Early Grading Permit - Final Drainage Report

Winsome Subdivision Filing No. 3 El Paso County, Colorado

Revise to
EGP-21-005

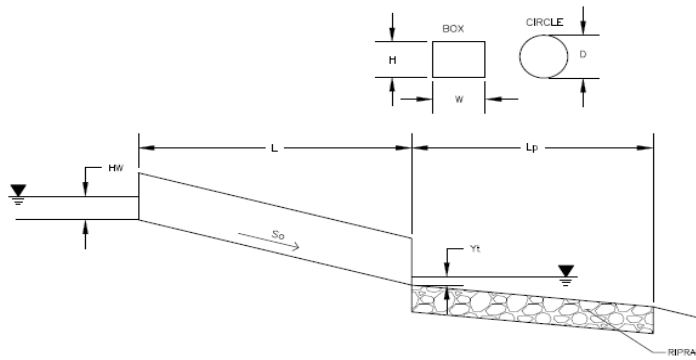
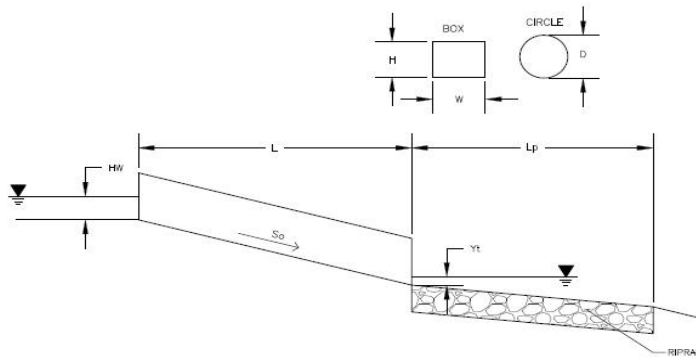
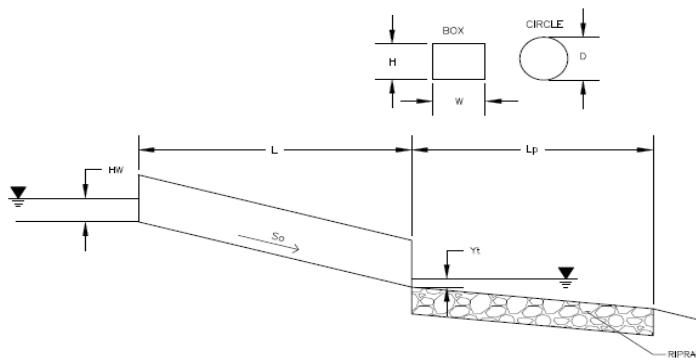
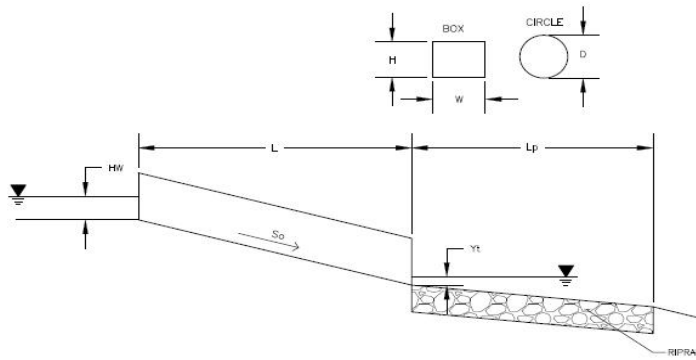
provide the specific culvert analysis for these roadway culverts. The only ones attached are for a general driveway culvert

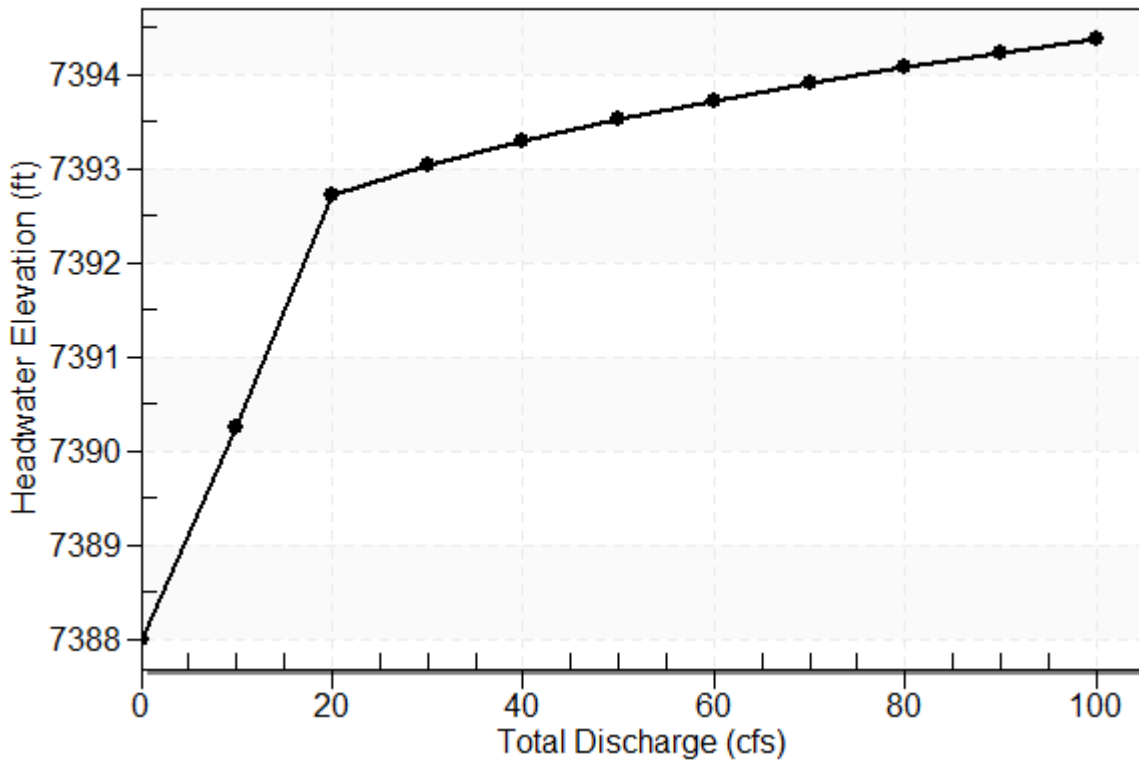
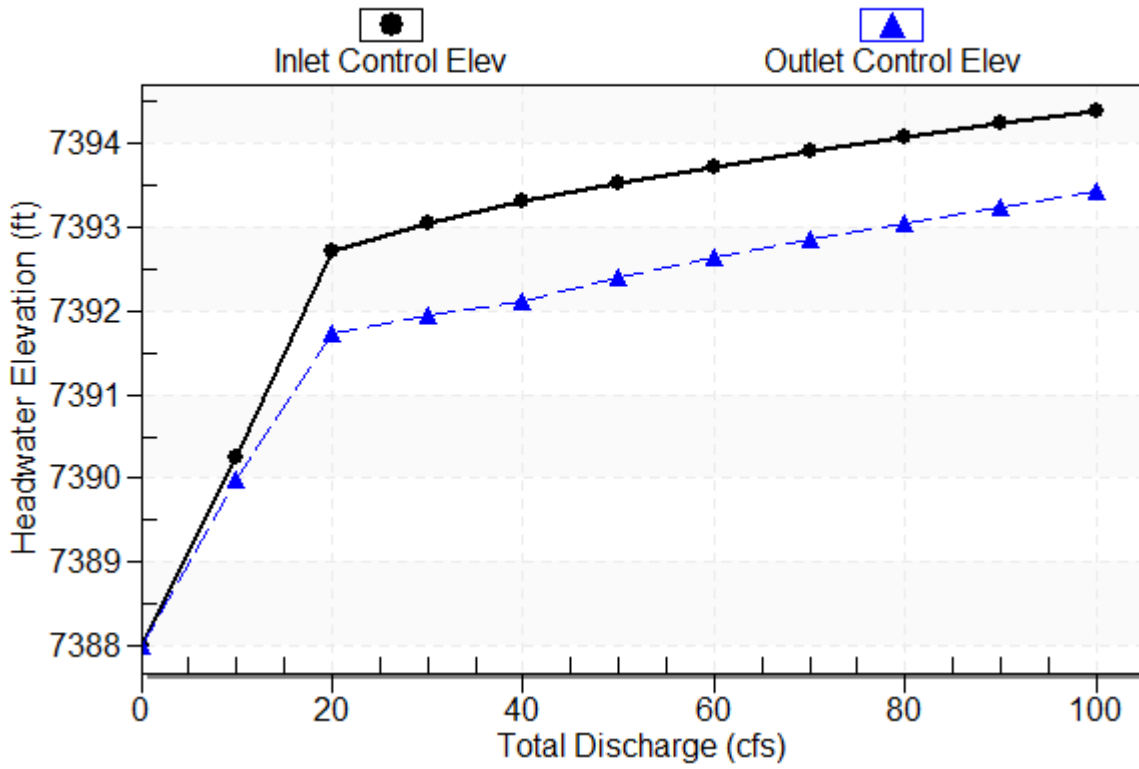
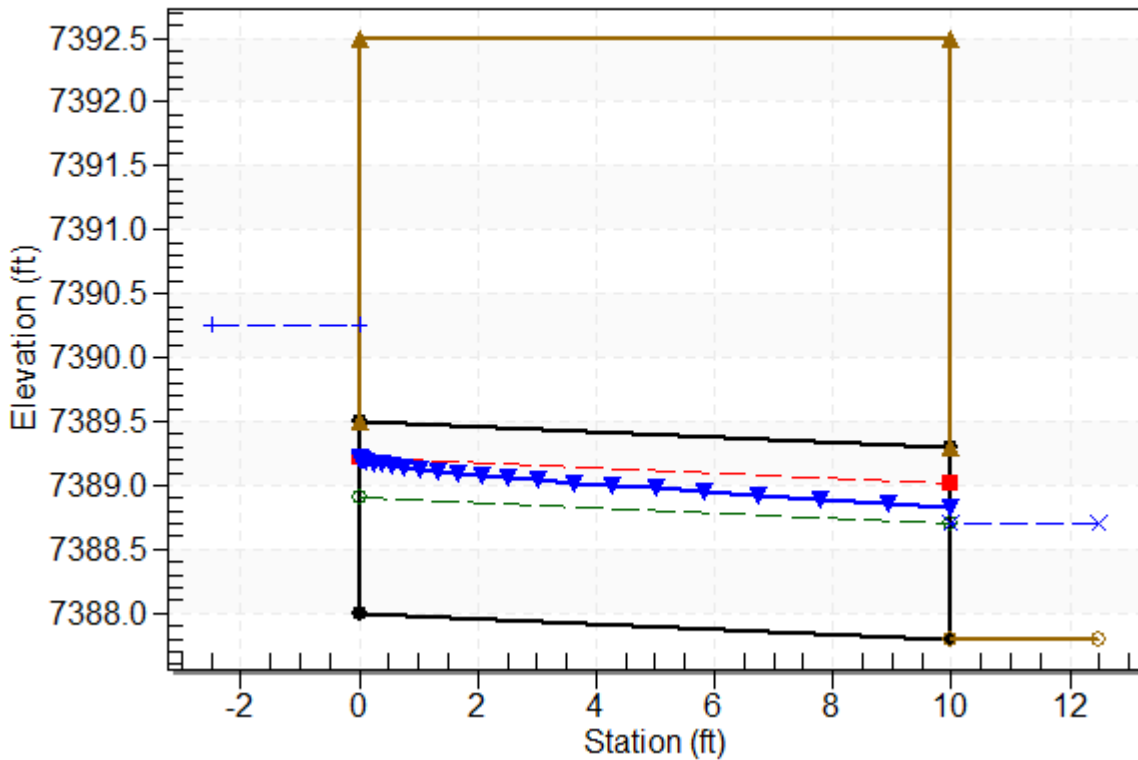
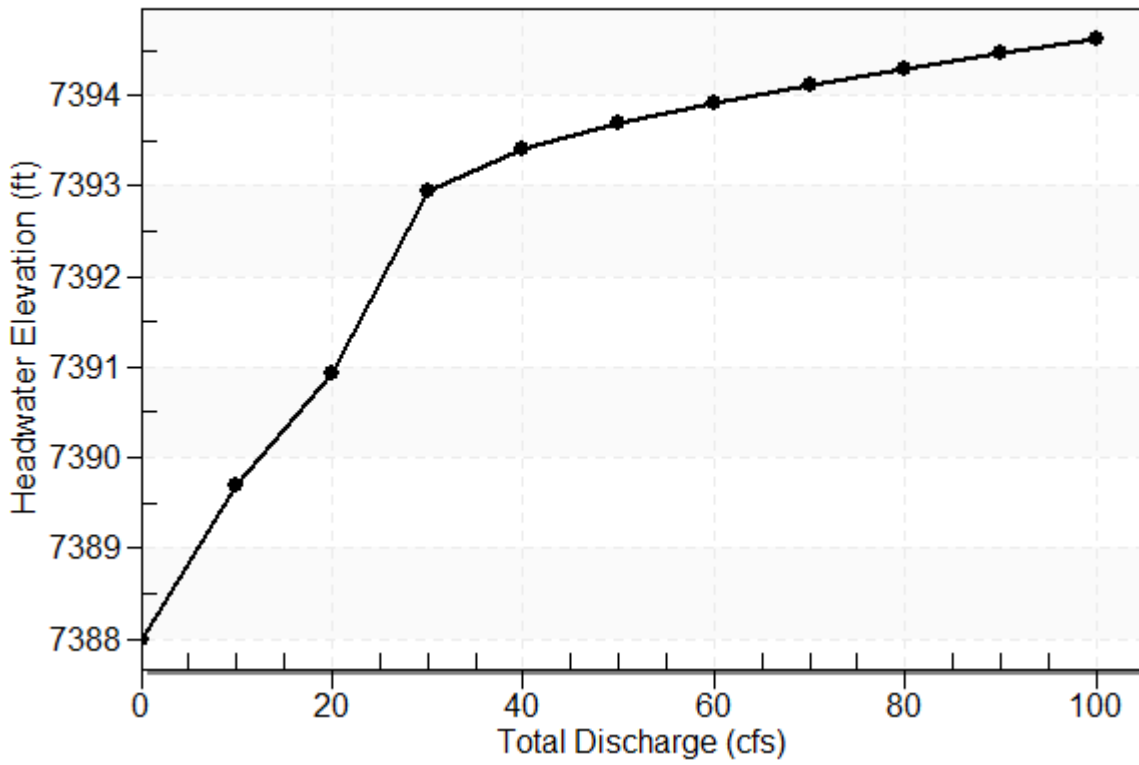
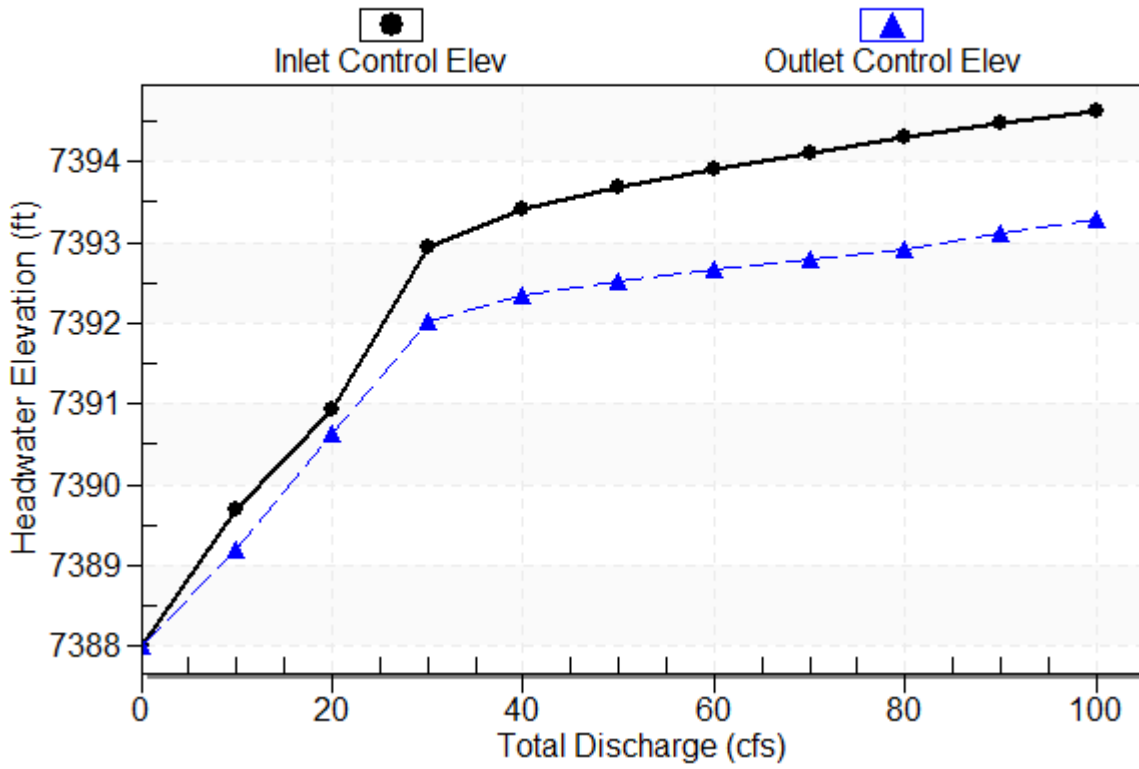
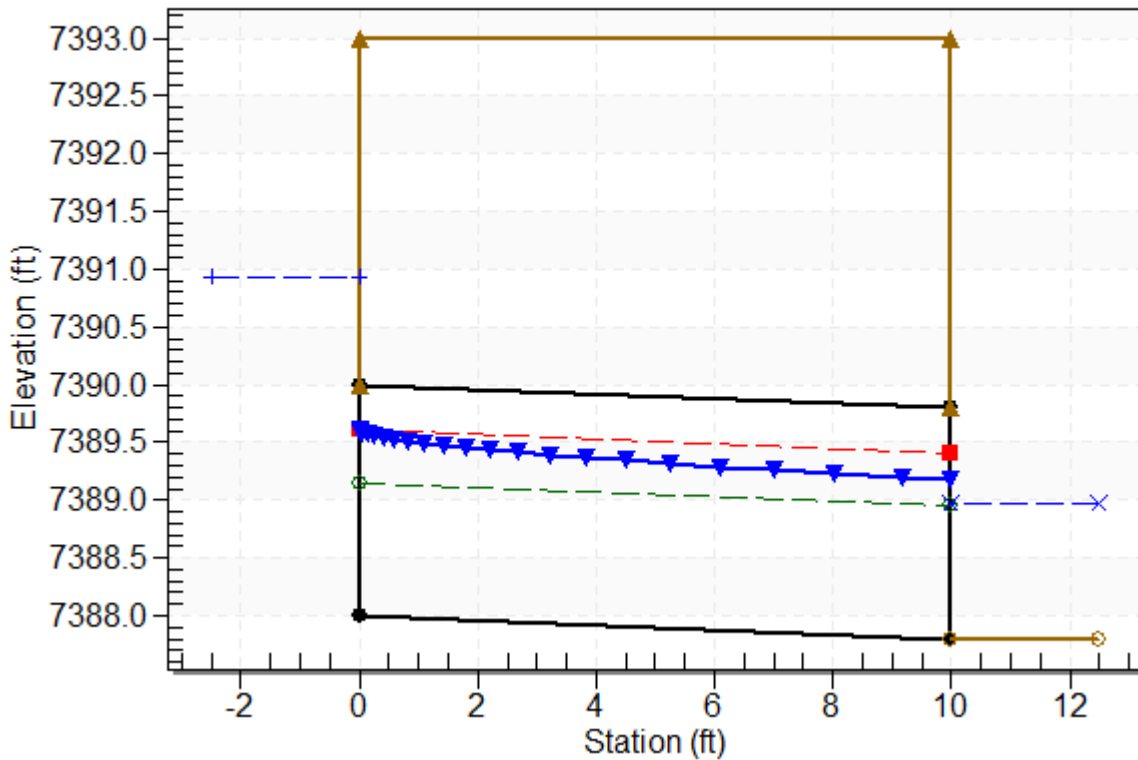
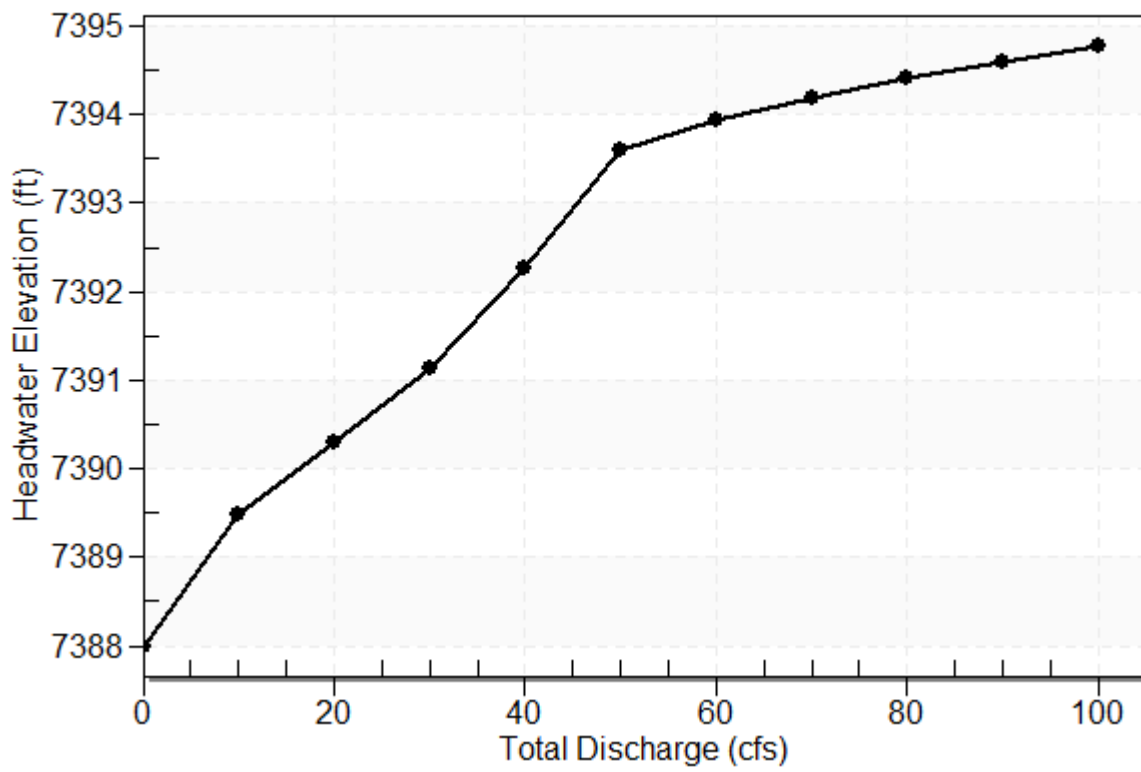
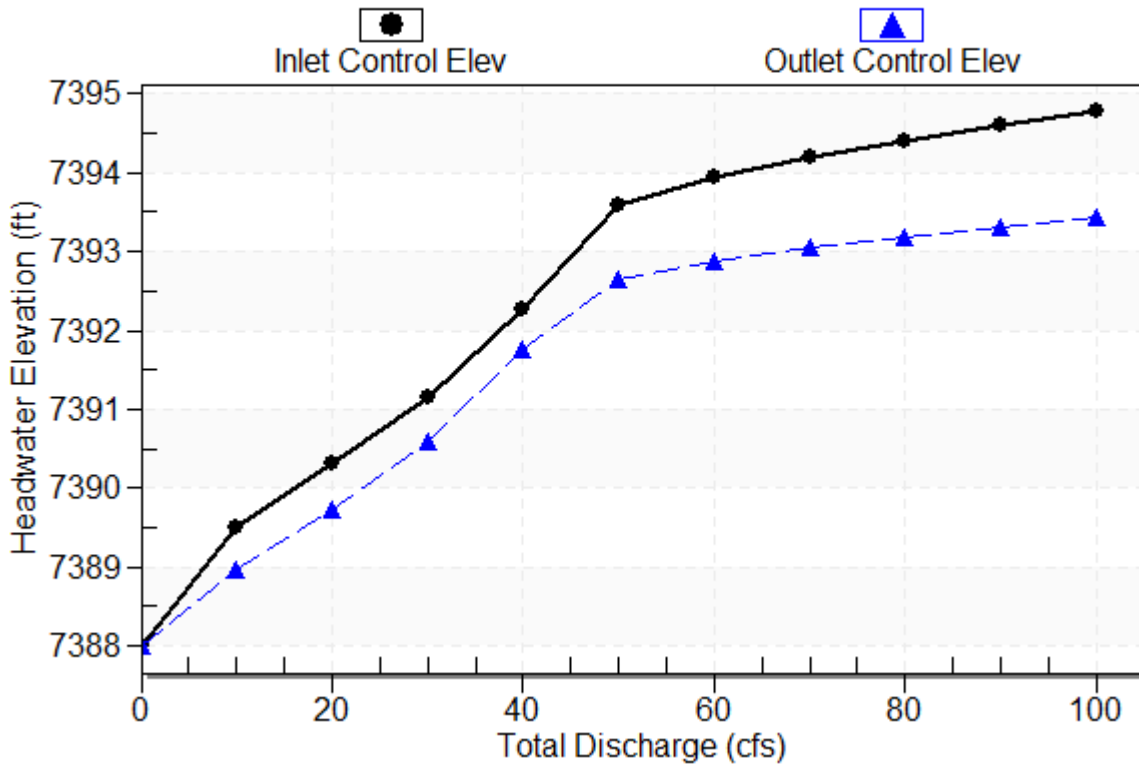
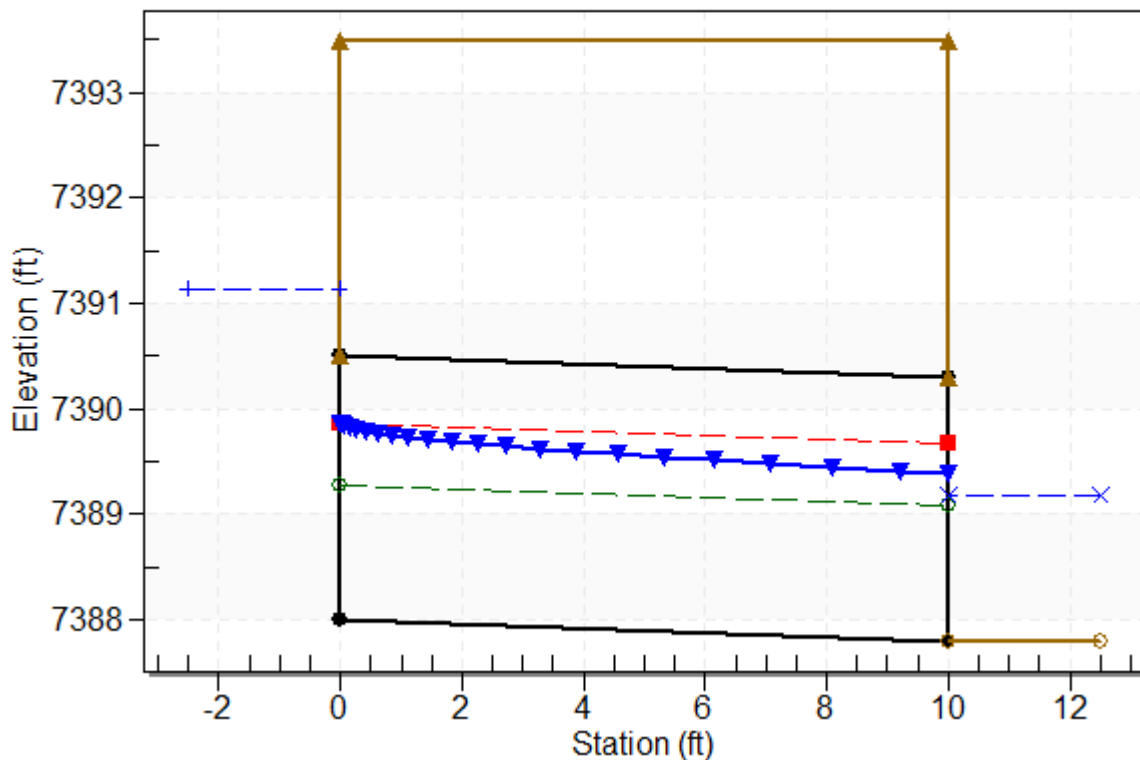
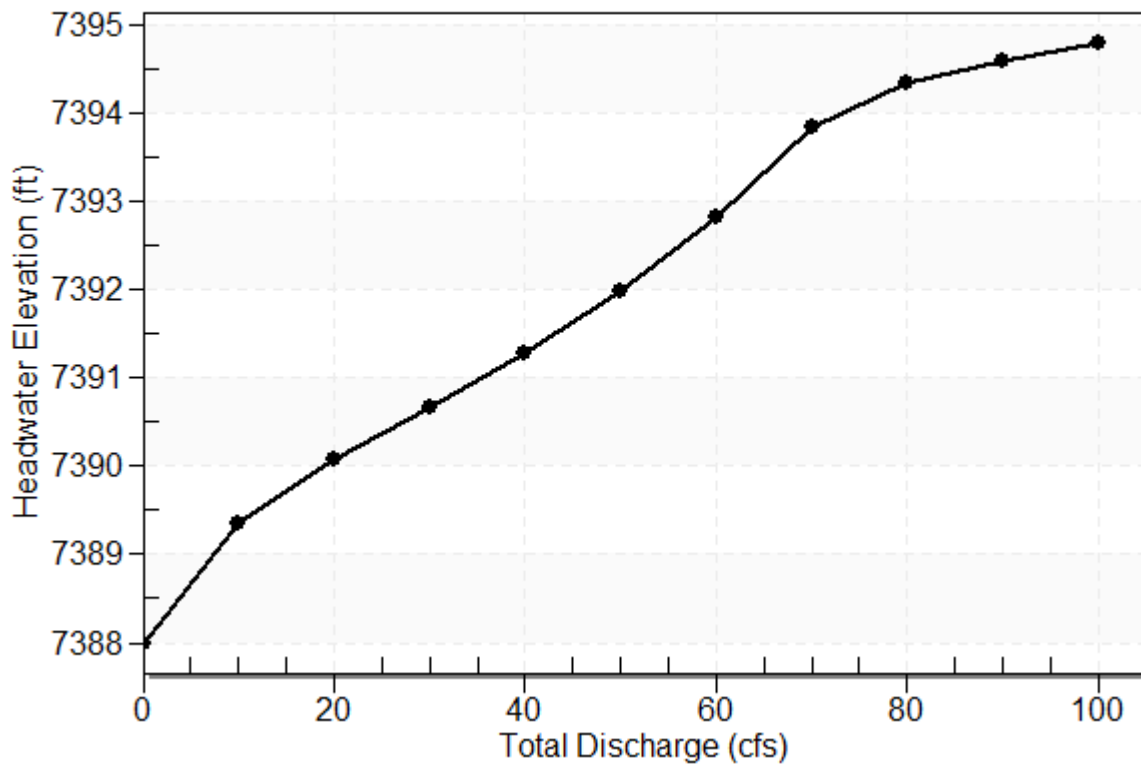
Remove the driveway summary table and supporting culvert analysis from the early grading application (EGP215). This will be reviewed approved with the Final Drainage Report associated with the future final plat application. See comment on page 13.
